Fil	e	1993-0122 Name: <u>Truck Terminal – 766 Valley Court</u>										
D	P S A few items are denoted with an asterisk (*), which means they are to be scanned for permanent record on the ISY											
r	c											
e	a	retrieval system. In some instances, items are found on the list but are not present in the scanned electronic development										
S	n	file because they are already scanned elsewhere on the system. These scanned documents are denoted with (**) and will										
e	n	be found on the ISYS query system in their designated categories.										
n t	e d	Documents specific to certain files, not found in the standard checklist materials, are listed at the bottom of the page.										
١	u	Remaining items, (not selected for scanning), will be listed and marked present. This index can serve as a quick guide for										
		the contents of each file.										
X	X	Table of Contents

#### PROJECT NARRATIVE AND IMPACT STATEMENT FOR A TRUCK TERMINAL FOR BASIN WESTERN, INC. FOR 766 VALLEY COURT GRAND JUNCTION, MESA COUNTY, COLORADO

FILE #122-93

TITLE HEADING: Site Plan Review - Truck Terminal

#### Review Comments on Truck Terminal #122-93

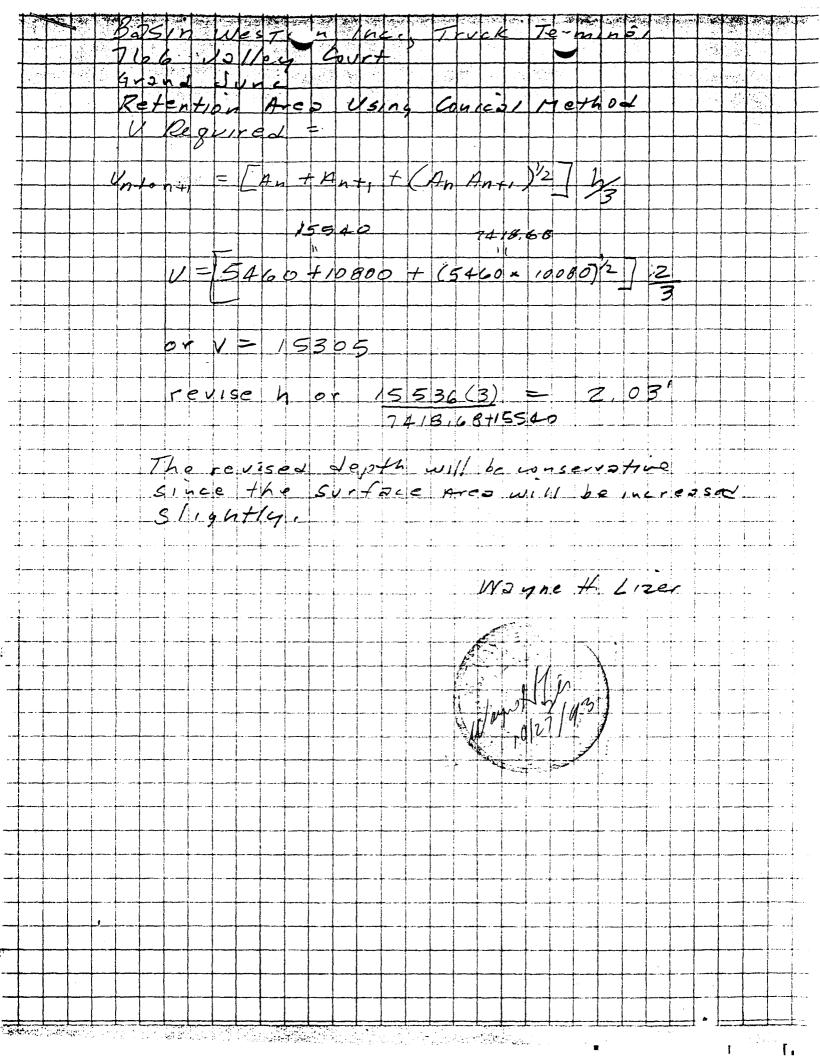
1. Calculate the retention volume using the conic method provided in the Drainage Criteria Manual, not the average end method.

- 2. Is the electric overhead or underground? Is it in an easement? Will it conflict with the proposed fire hydrant waterline? Is the water line proposed in an existing power easement?
- 3. Show a valve on the fire hydrant waterline.
- 4. What is the manhole invert elevation north of the site?
- 5. What is the manhole invert elevation south of the site?
- 6. What is the sewer pipe slope?
- 7. Show water and sewer services, and the proposed sand/grease trap. Provide a detail of the sand/grease trap.
- 8. Provide for erosion control down embankment.

- 1. Retention system addressed as requested on site plan.
- 2. Electric service is overhead to pole as shown on site plan with underground to facility. Power service is on site and not on easement. New fire hydrant will be located to the West of electric power supply and not conflict. Water line will not be in an easement.
- 3., 4., 5. All are addressed as requested on site plan.
- 6. Sewer pipe from tap will be slope of 1/8" per 1'.
- 7. Services shown on site plan and copy of planned separator attached.
- 8. Erosion control addressed on site plan.
